Well Name: POKER LAKE UNIT 28 BS	Well Location: T25S / R31E / SEC 28 / SWNW / 32.101875 / -103.7896	County or Parish/State: EDDY / NM
Well Number: 108H	Type of Well: OIL WELL	Allottee or Tribe Name:
Lease Number: NMLC062140A	Unit or CA Name: POKER LAKE UNIT	Unit or CA Number: NMNM71016X
US Well Number: 3001555764	Operator: XTO PERMIAN OPERATING LLC

Type of Submission: Notice of Intent

Type of Action: APD Change

POKER LAKE UNIT 28 BS 113H

DATE: 12-3-2024 PROJECT NO: 2023040158
 DRAWN BY: LM SCALE: 1" = 2,500'
 CHECKED BY: CH SHEET: 2 OF 2
 FIELD CREW: IR REVISION: 1

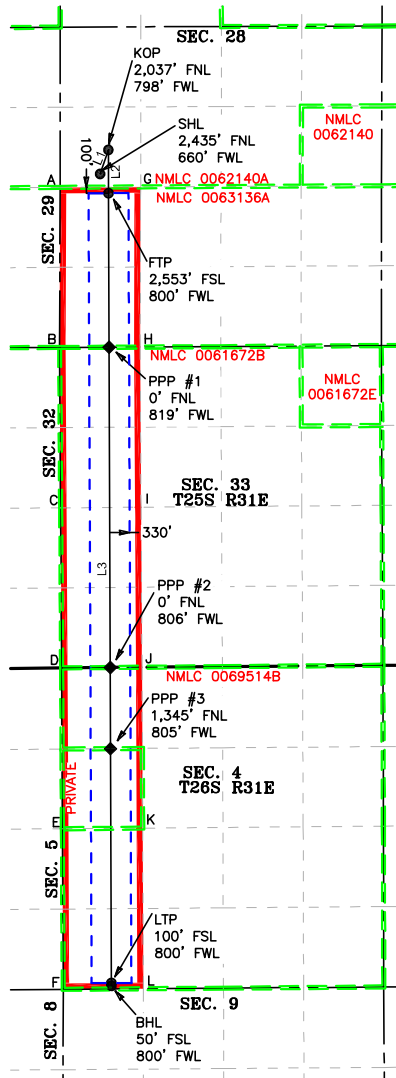
APD ID number 10400094326 has an approved API number of 30-015-55764. XTO Permian Operating, LLC. respectfully requests approval to make the following changes to the approved APD. Name change FROM Poker Lake Unit 28 BS 108H TO Poker Lake Unit 28 BS 113H. Changes also include KOP, FTP, LTP, BHL, & Proposed total Depth. There will be no additional surface disturbance. There is a dedicated acreage change.

FROM: TO:

KOP: 2435 FNL & 660 FWL OF SECTION 28-T25S-R31E 2037 FNL & 798 FWL OF SECTION 28-T25S-R31E

FTP: 2435' FNL & 330' FWL OF SECTION 28-T25S-R31E 2553' FSL & 800' FWL OF SECTION 28-T25S-R31E

LTP: 100' FSL & 330' FWL OF SECTION 4-T26S-R31E 100' FSL & 800' FWL OF SECTION 4-T26S-R31E

BHL: 50' FSL & 330' FWL OF SECTION 4-T26S-R31E 50' FSL & 800' FWL OF SECTION 4-T26S-R31E

The proposed total depth is changing from 23706 MD; 9891 TVD (Bone Spring) to 24343 MD; 10780 TVD (Bone Spring).
